**COMMENT RESOLUTION FOR THE
GROUND WATER ASSESSMENT PLAN ADDENDUM,
1989 AND 1990 ANNUAL GROUND WATER MONITORING
REPORTS FOR ROCKY FLATS PLANT**

**COMMENT RESOLUTION, CDH COMMENTS ON THE
GROUND WATER ASSESSMENT PLAN ADDENDUM**

TITLE
PROPOSED MONITORING WELL LOCATION MAP
FIGURE 4-37

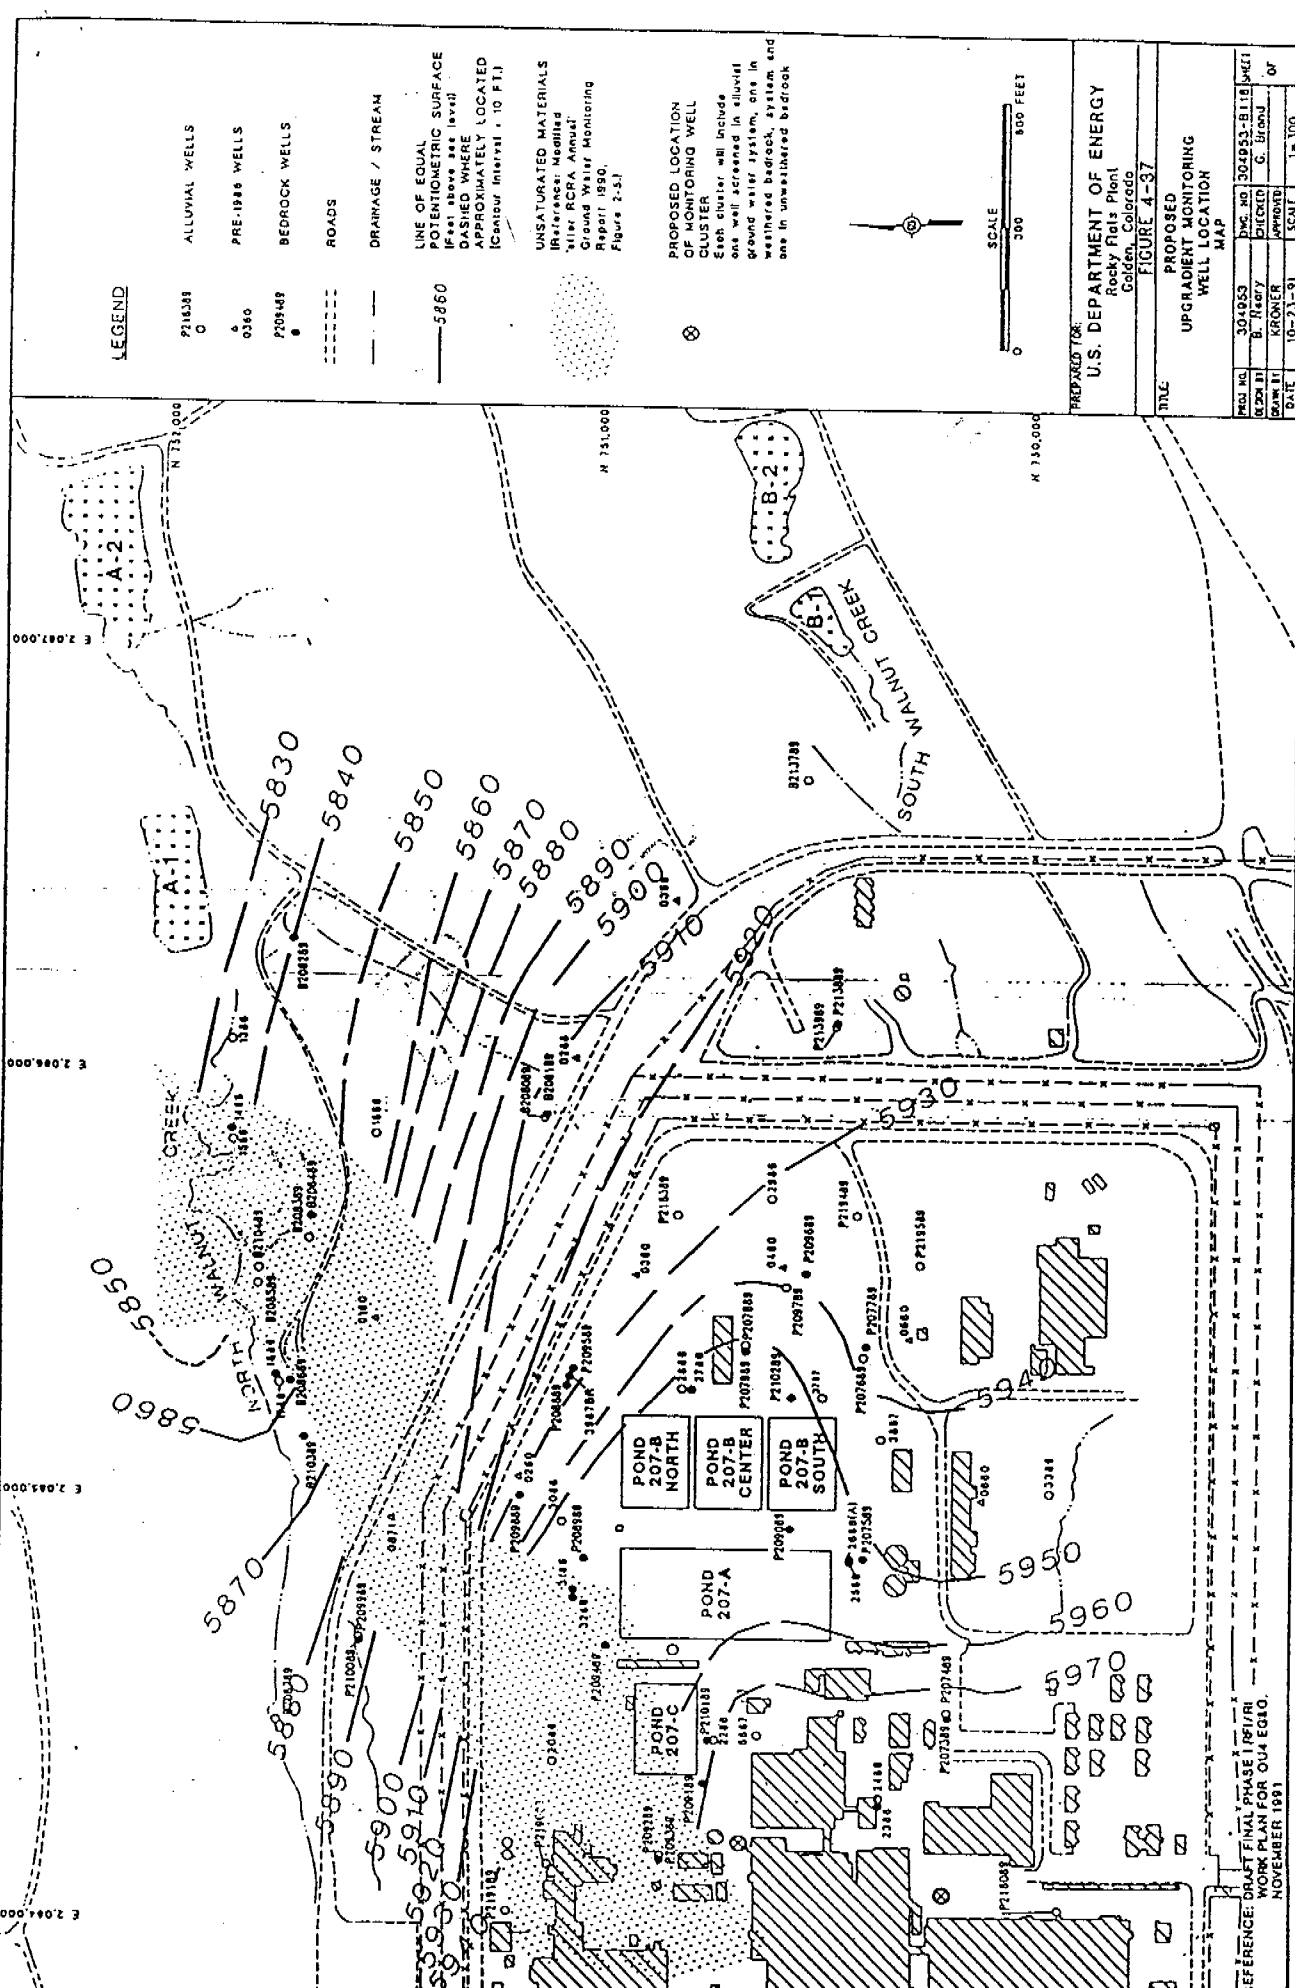
Response to Comment 8: SECTION 3.3 PROPOSED MODIFICATIONS (Solar Evaporation Ponds) Six more wells are proposed upgradient of the SEPs. Attached is a map showing the new proposed monitoring well locations. One set of cluster wells will be located west of the wells 2286 and P210189 to further characterize upgradient contamination. The proposed future activities at the Solar Evaporation Ponds are described in section 4.3.3 Future Activities. Wells are discussed in section 4.3.3.2 Proposed Monitoring Well Locations and section 4.3.3.3 Sampling Program and Analytical Methodologies.

FIGURE 4-26

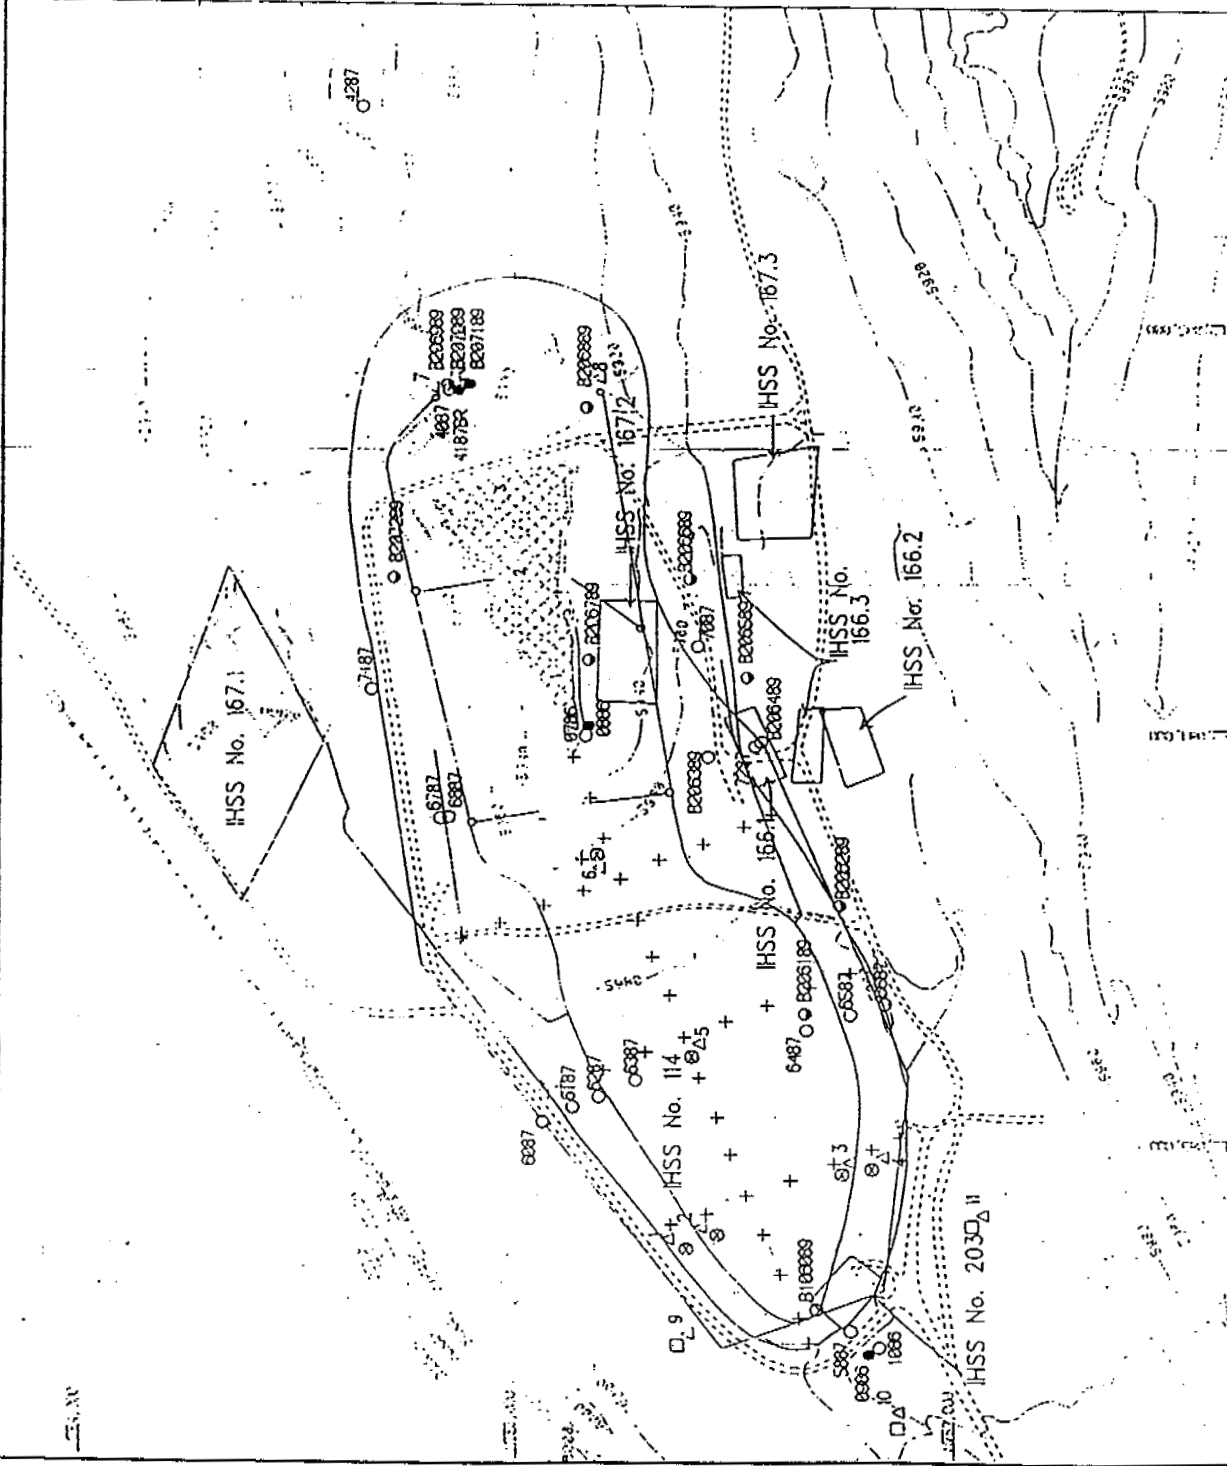
1. The sandstone underlying the Present Landfill needs further characterization to determine if it is a preferential path for groundwater and contamination. However, the results of the Ground Penetrating Radar Survey were unsuccessful in locating bedrock or sand channels and will not be used to locate monitoring wells. Proposed characterization of the bedrock sandstone includes three borings upgradient of the Present Landfill. The deepest well of each cluster is projected to intersect this sandstone. The attached map show the proposed locations. These are described in section 4.2.3.2 Proposed Monitoring Well Locations.

2. For wells constructed in the landfill where the saturated interval exceeds 10 feet, well pairs are now proposed. One well will be screened from three feet above water level to seven feet below and the second well will be screened in the bottom five feet of the saturated zone. These well pairs will more adequately characterize the contamination and determine if there is vertical migration of contaminants. Section 4.2.3.2 Proposed Monitoring Well Locations describes these well pairs.

15 new monitoring wells and 11 borings are proposed as part of the RFI/RI work plan for further characterization of the area. Section 4.2.3.2 Proposed Monitor Well Locations lists these new wells.
